LANCASTER SUBDIVISION, PHASE ONE

APPLICATION NUMBER 6 DATE August 18, 2011

REQUEST Subdivision

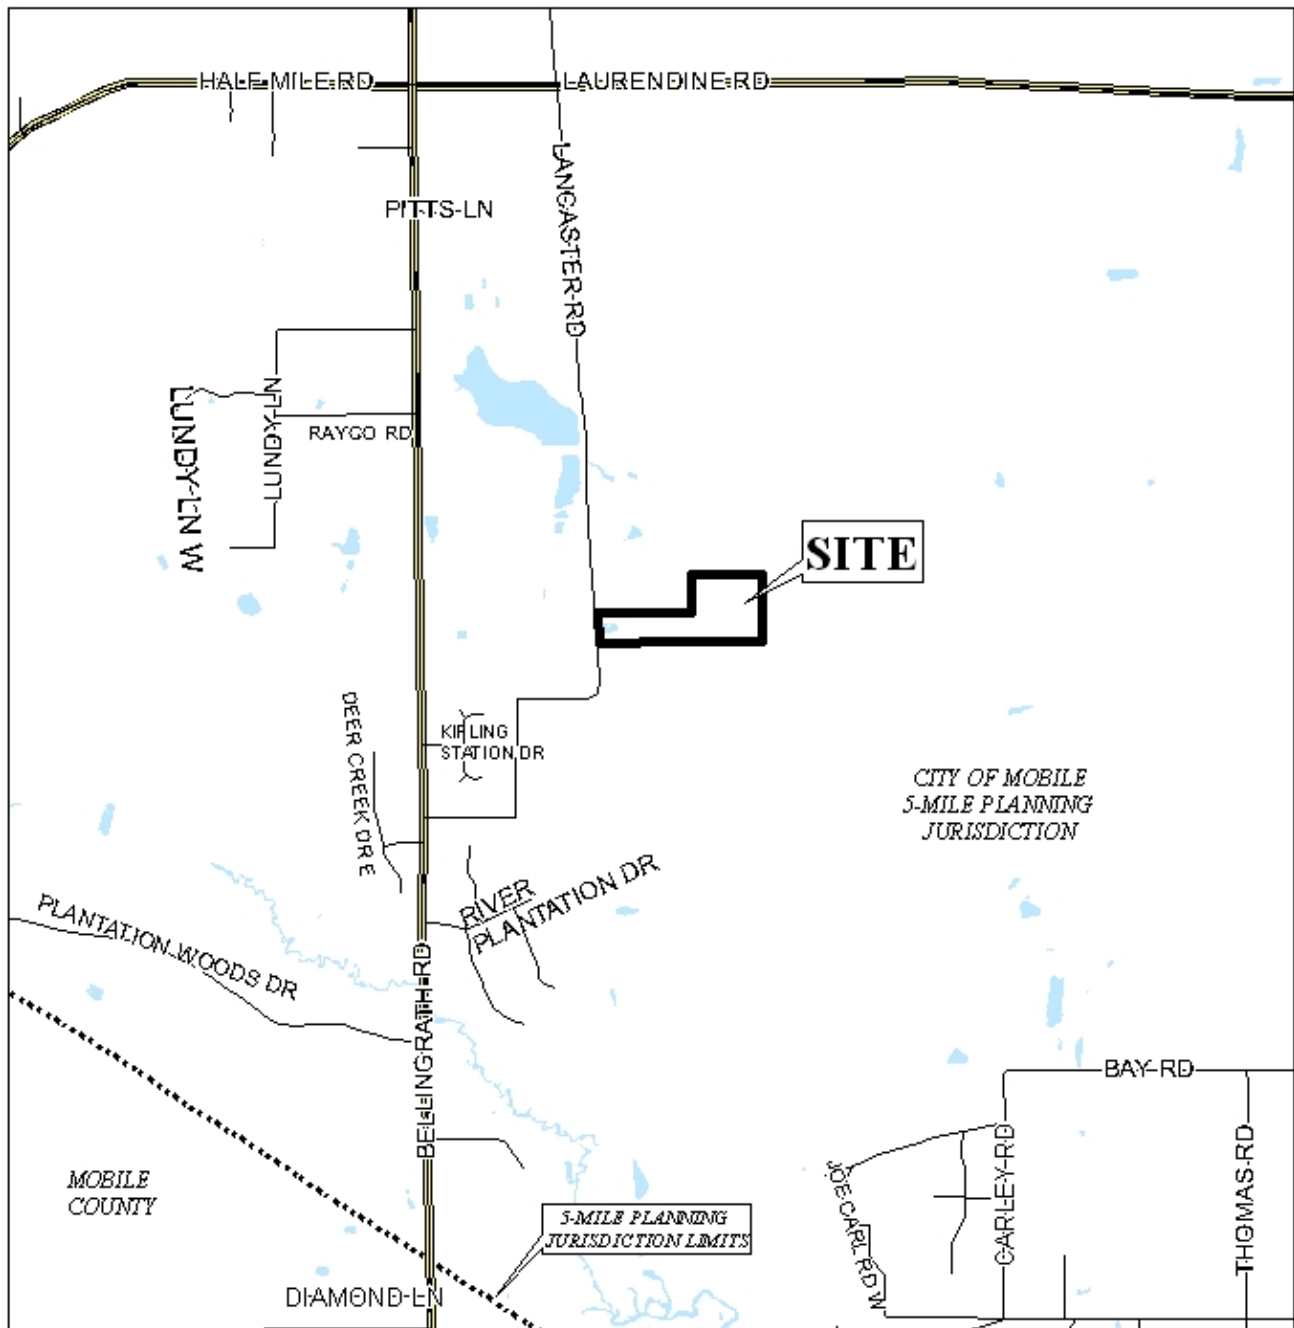
The proposed lots meet the minimum size and frontage requirements of the Subdivision Regulations. The 25-foot minimum building setback line and lot area sizes, in square feet, are depicted on the preliminary plat.

The site fronts Lancaster Road, a minor street not provided with curb and gutter. Lancaster Road is depicted with an adequate right-of-way of 60 feet, and, as such, no dedications should be required.

None of the three lots, as proposed, meet Section V.D.3. of the Subdivision Regulations regarding width to depth ratio; further, the proposed Lots 2 and 3 are flag-shaped. While flag-shaped lots usually have a "flagpole" of less than 60 feet in width, these lots, nevertheless, constitute flag-shaped lots. Section V.D.1. of the Subdivision Regulations states that "*Requests for panhandle or flag lots shall be accompanied by evidence showing that each panhandle or flag lot is necessary to allow the site owner reasonable use of the site or to alleviate a situation that would otherwise cause extreme hardship.*" The applicant provided no information regarding justification for flag lots, whether because of natural features or a family subdivision.

Further, the Section also states that "*Multiple panhandle or flag lots shall not be allowed as an alternative to road construction*". There is ample space to provide a public road to allow development on the site. It should be noted that while there are some flag-shaped lots in the area of this site, flag-shaped lots are not common and the informality of design is not consistent with other lots in the vicinity.

- 1) the proposed Lots 2 and 3 do not comply with Section V.D.1. of the Subdivision Regulations regarding flag-shaped lots; and
- 2) none of the lots comply with Section V.D.3. of the Subdivision Regulations regarding the maximum width to depth ratio.
